# Access Compliance Report

## Public Rights-of-Way

### (Curb Ramps)

Intersection ID: N/A	Main Street: HICKORY GROVE RD	Cross Street: SUSAN DR	Location: NE
ADA ID: 90A3E5368A23	Ramp Type: Combination1	Initial Pass/Fail: Fail	Overall Compliance: No
		Severity Score: 37.5

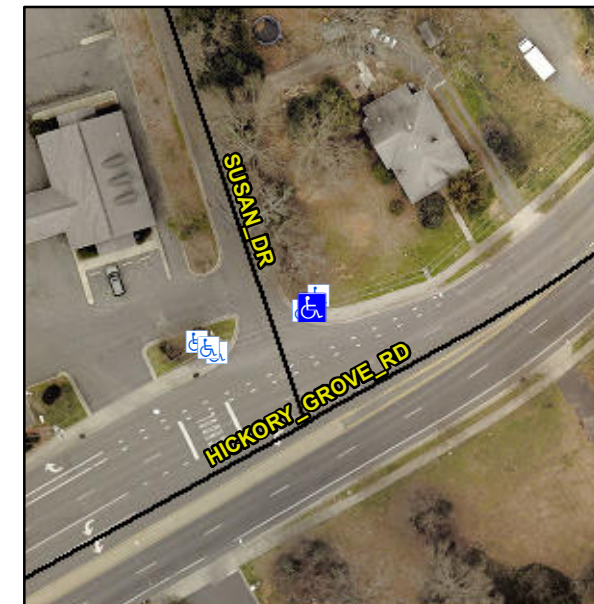
**Not Found, R304.2.2, R304.5.3, R304.3.2**

Compliance	Description	Data	Compliance	Description	Data
N/A	Ramp Length LT (in)	64.0	N/A	Ramp Length RT (in)	39.0
Yes	Ramp Width LT (in)	73.0	Yes	Ramp Width RT (in)	75.0
Yes	Ramp Slope LT (%)	2.5	No	Ramp Slope RT (%)	11.8
No	Ramp XSlope LT (%)	2.8	Yes	Ramp XSlope RT (%)	0.5
N/A	Ramp Length (in)	73.0	No	Ramp Slope (%)	9.0
Yes	Ramp Width (in)	48.0	No	Ramp XSlope (%)	7.5
N/A	Flare Type LT	N/A	N/A	Flare Type RT	N/A
N/A	Flare Slope LT (%)	N/A	N/A	Flare Slope RT (%)	N/A
N/A	Flare Traversable LT?	N/A	N/A	Flare Traversable RT?	N/A
N/A	Landing Length (in)	N/A	N/A	DWS Provided?	N/A
N/A	Landing Width (in)	N/A	N/A	DWS Contrast?	N/A
N/A	Landing Slope (%)	N/A	N/A	DWS Length (in)	N/A
N/A	Landing X Slope (%)	N/A	N/A	DWS Full Width?	N/A
N/A	Landing Curb? (Y/N)	N/A	N/A	DWS Offset (in)	N/A
N/A	Shared Landing?	N/A			
N/A	Gutter Ponding?	N/A	N/A	Gutter Slope (%)	N/A
N/A	Gutter Lip Ht (in)	N/A	N/A	Gutter X Slope (%)	N/A
N/A	Painted X Walk1?	No	N/A	Painted X Walk2?	N/A

**Remove & Replace Entire Ramp.**
